Referee 1:

This is an interesting evaluation of the SenseAir K30 sensors, co-located with Picarros, over a 30 month timescale. This is a valuable study, but the manuscript needs significant revision to properly categorize sensor types and adjust all comparisons accordingly, address scalability concerns, strengthen the literature context, and better acknowledge limitations. It should be accepted for publication in AMT if the following can be addressed.

Figure 1. The temperature and humidity variation of LCS instruments under (a) indoor, (b) beside the window, and (c) field conditions during the experimental period.

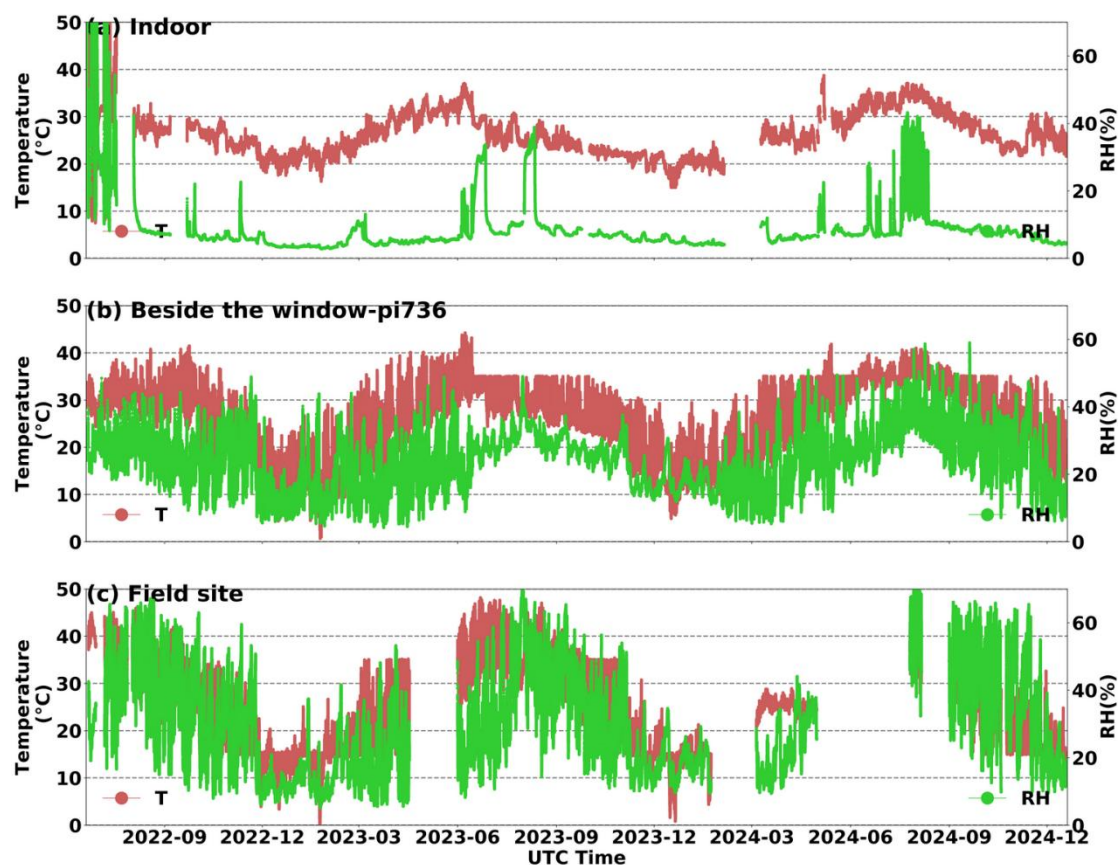
Why can you say that hanging on an open window is the same a field-deployment? If the instruments are even partially indoors surely they are more temperature controlled than a true field deployment?

Response: Thank you for this question. Due to the limitation of experimental conditions, we set the instruments at the edge of the open window to directly take in the outside air. We compared the observed environmental conditions of indoor, our set-up instruments, and out door field in the following figure 1 (Also added in Fig. S8). We show that the instruments shared almost the same changing environments as the out door air conditions. The temperature mainly ranged from 0-40 °C, and the RH mainly ranged from 0-60%. And both if they are quite different from the indoor conditions. We added these discussions in lines 222-232.

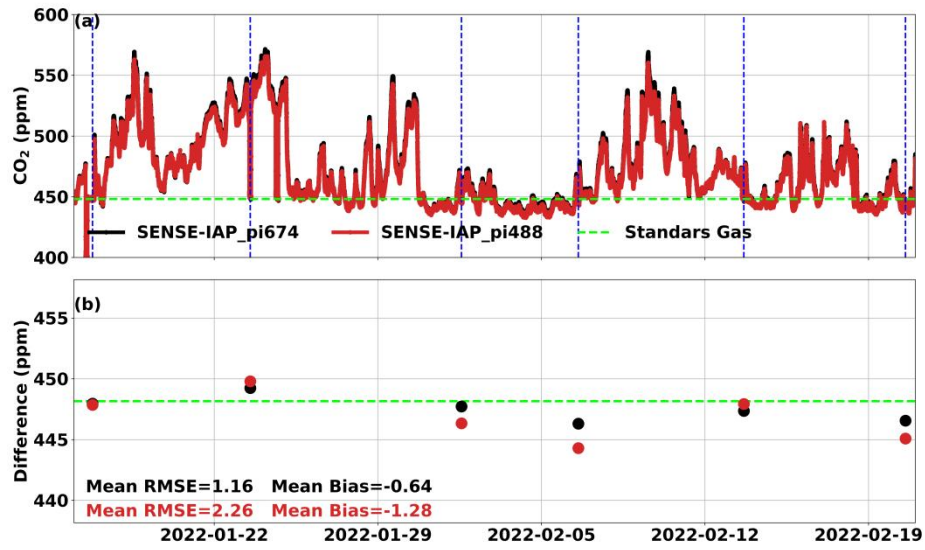
Have the authors explored alternatives to a co-location for drift correction every 3-6 months? This may not be feasible for large deployments. Did the authors explore the performance of a remote calibration strategy at all? How would the proposed calibration scale (in cost/time) to, say, 100s of sensors deployed?

Thank you for these valuable suggestions. We added discussions in lines 65-80. Indeed, this may not be feasible for large deployments, it is useful to understand the sensor performance and characteristics in long-term drifts, and suggest us the calibration frequency after deployment. We also explored several other calibration methods for drifts. One robust and commonly used method is automatic/manual standard gas calibration. We used this standard gas method in the Beijing and Jinan networks with more than 160 instruments, the calibration frequency is one week for automatic standard gas, and 1-3 months for manual calibration, and the results showed mean biases -1.28 ~ -0.64 ppm with standard gas at one month scale (Cai et al., 2024) (below figure). The manual standard gas calibration is useful in mobile observations such as on-road observations using vehicles and vertical profile observations using tethered balloons (Liu et al., 2021; Bao et al., 2020).
